Modification Recommended Service Note

P5005B Keysight Streamline Vector Network Analyzer

Serial Numbers: From MY61100009 to MY61100135

Potential lifted front panel overlay

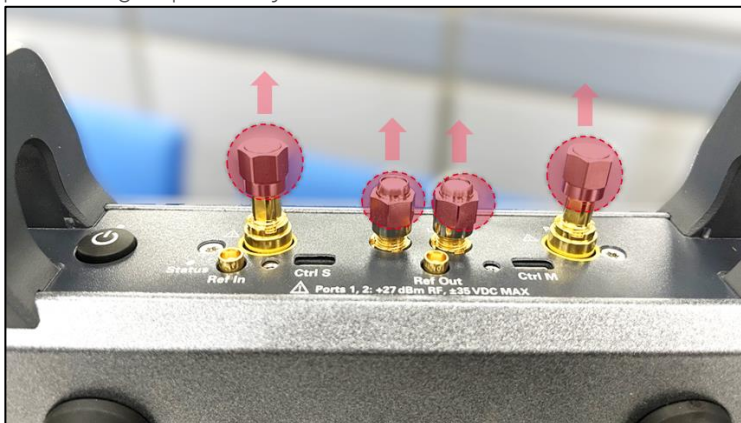
Keysight streamline series vector network analyzer (VNA) of serial number range identified in service note cover page might potentially exhibit the following lifted front panel overlay symptom.

Apart from cosmetic imperfections, the lifted front overlay could have led to non-fully attached *Ctrl S* micro-HDMI cable connector in multi-VNAs setup configuration.

-> Apply this service note only if end users' VNA is exhibiting the following symptom.

Procedure to replace the front panel overlay.

1. Remove the front handles. Detach the 50-ohm termination (LO-In, LO-Out, Port 1 & Port 2) or protecting caps if they are attached to the VNA.

2. Pry open the existing front panel overlay and remove it from front panel.
3. Clean the metal surface thoroughly and ensure it is free of adhesive residue.
4. Affix the new self-adhesive front panel overlay onto the metal surface.
5. Reinstall (reuse) the 50-ohm terminations and port protecting caps accordingly.

6. Reinstall (reuse) the front handles.
